REACTOR COOLANT SYSTEMOPERATIONAL LEAKAGELIMITING CONDITION FOR OPERATION

3.4.3.2 Reactor coolant system leakage shall be limited to:

PROPOSED TECHNICAL SPECIFICATION INSERT CHANGE TO BASES  
SECTION 2.0 PARAGRAPH 8

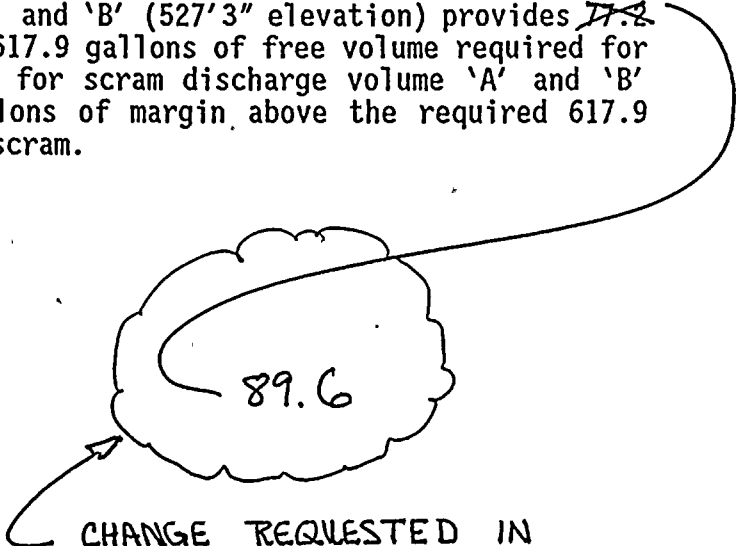
for scram discharge volume 'A' (525'4 1/2" elevation) provides 87.1 gallons of margin above the required 617.9 gallons of free volume required for a reactor scram. The scram discharge volume high level alarm setpoint for scram discharge volume 'B' (524'7" elevation) provides 91.3 gallons of margin above the required 617.9 gallons of free volume required for a reactor scram. The rod block setpoint for scram discharge volume 'A' and 'B' (527'3" elevation) provides ~~77.2~~ 89.6 gallons of margin above the required 617.9 gallons of free volume required for a reactor scram. The scram setpoint for scram discharge volume 'A' and 'B' (529'7" elevation) provides 64.9 gallons of margin above the required 617.9 gallons of free volume for a reactor scram.

CHANGE REQUESTED IN  
THIS LETTER

89.6
